**ADDENDUM NO. 1**

**November 23, 2022**

**PROJECT:** FY2022 LMIG – Full Depth Reclamation, Leveling, Overlay, and Stripping of Various County Roads  
I&A Project No.: 1160-116-01

**OWNER:** Jones County Board of Commissioners

UPDATED SITE DEVELOPMENT LAYOUT

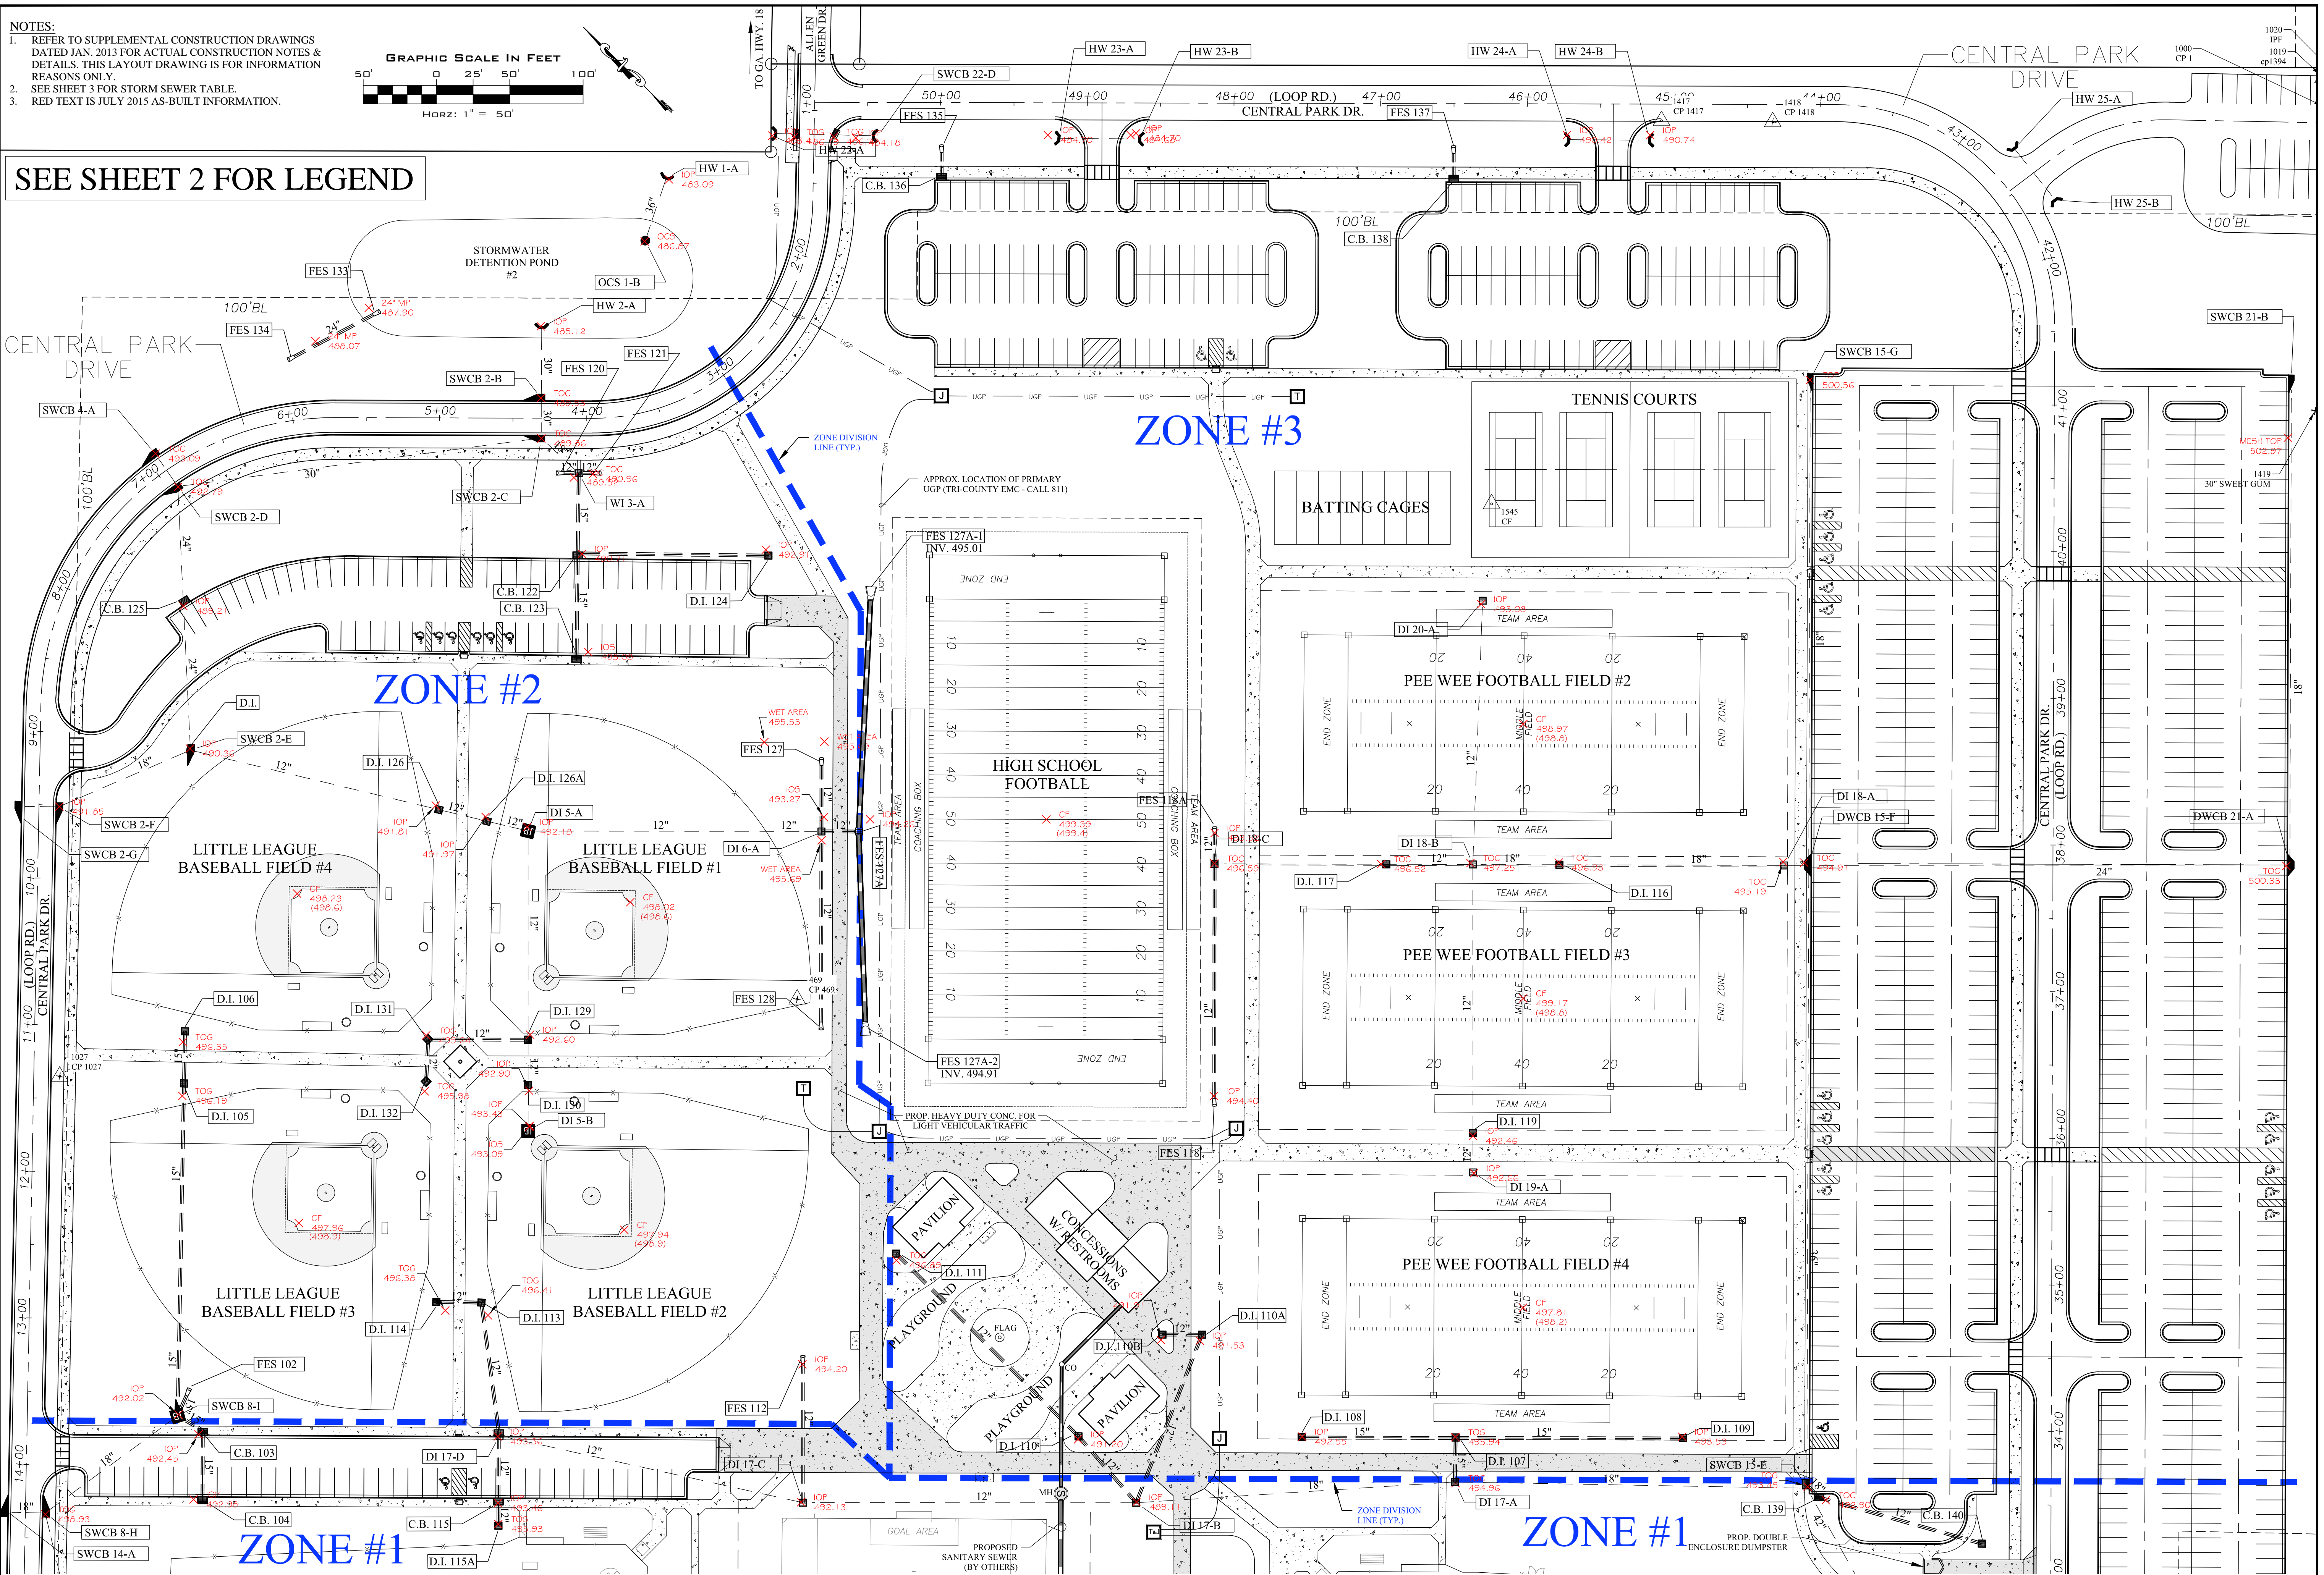
**Item 3- ADDITION:** Insert the attached Updated Site Development Layout

**The backfill dirt used must grow grass. If it does not grow grass, then it will have to be removed and replaced.**
- 12) On the Hwy 18 Rec Complex Patio it calls for removing the existing gravel. Should 2.25" of gravel be removed for the asphalt alternate and 4" be removed for the concrete alternate or should 100% of the gravel be removed? Please clarify with detail drawings.

**Yes, A layout of the Complex Patio is included.**
- 13) Where should the removed gravel be haul to and or stockpiled?  
**In the back parking lot of the recreation complex. No material will be taken off site.**

DETAIL FOR PAVING TURNOUTS FOR SIDE ROADS, STREETS, AND DRIVES

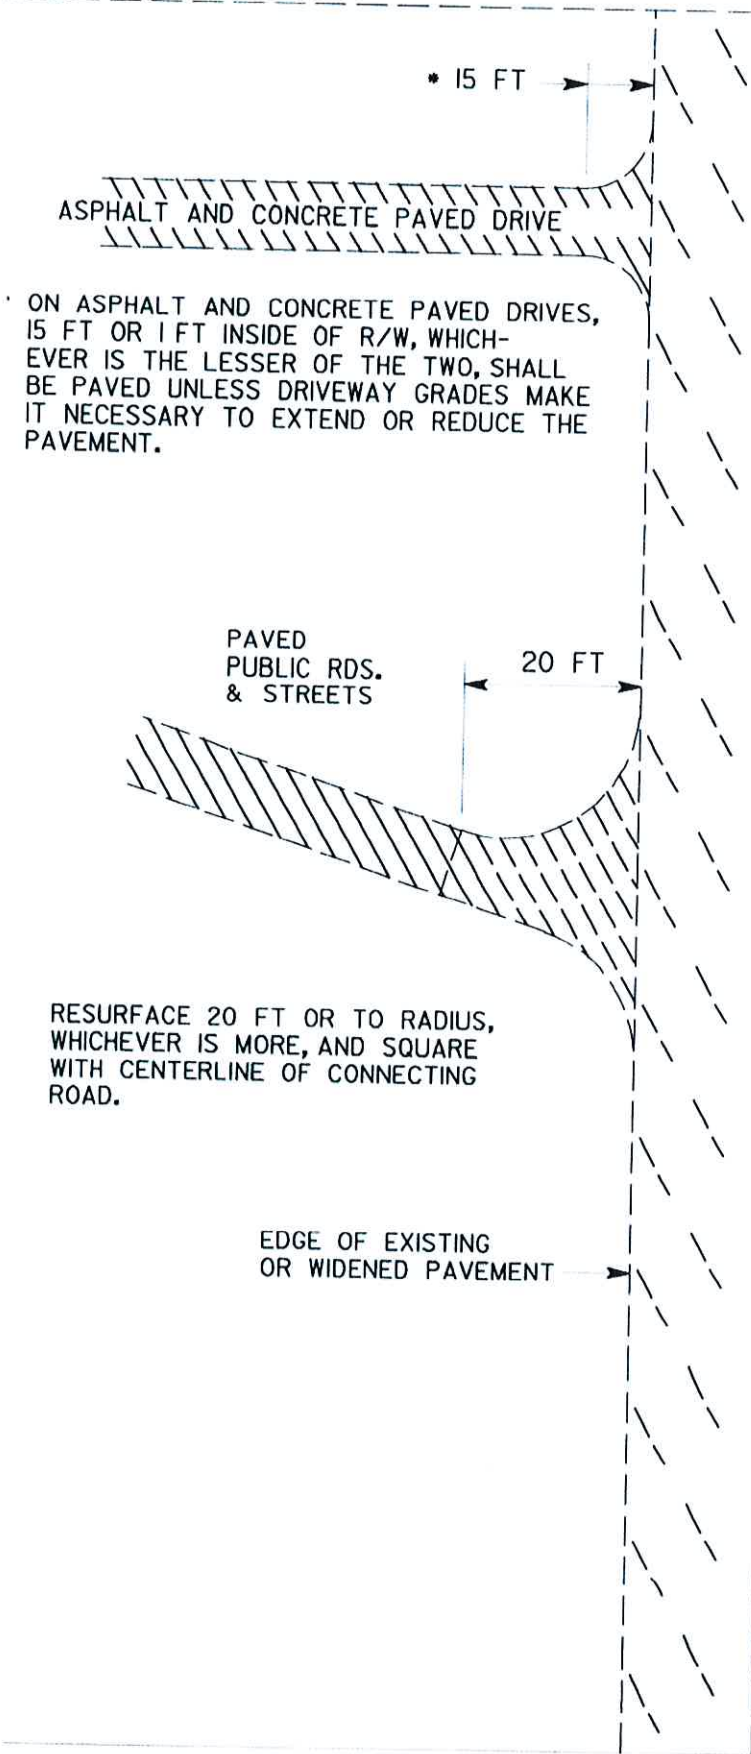
- 24) Will the contractor be required to pave into side roads?  
**Yes. A detail was provided in proposal to address this concern. (attached)**
- 25) How long can the milled parking lot at the Jones Co. Animal Shelter remain without asphalt paving?

36) On sideroads and driveways, there is a GDOT typical section that says pave back 15' on drives and 20' on sideroads. We don't think we have done this in the past for Jones County. Is this the intent or will a gate kickout be sufficient?

On some of the routes the proposed typical section and with the property owners existing driveway conditions, it will be significant higher in elevation creating a potential issue for smaller vehicles to access the roadway with only running gate out a short distance. The intent of paving the 15' +/- distance is to provide a smooth transition from their existing driveway to the newly resurfaced roadway. All driveways on these selected routes may not require paving the additional driveway distance of 15'+/-.
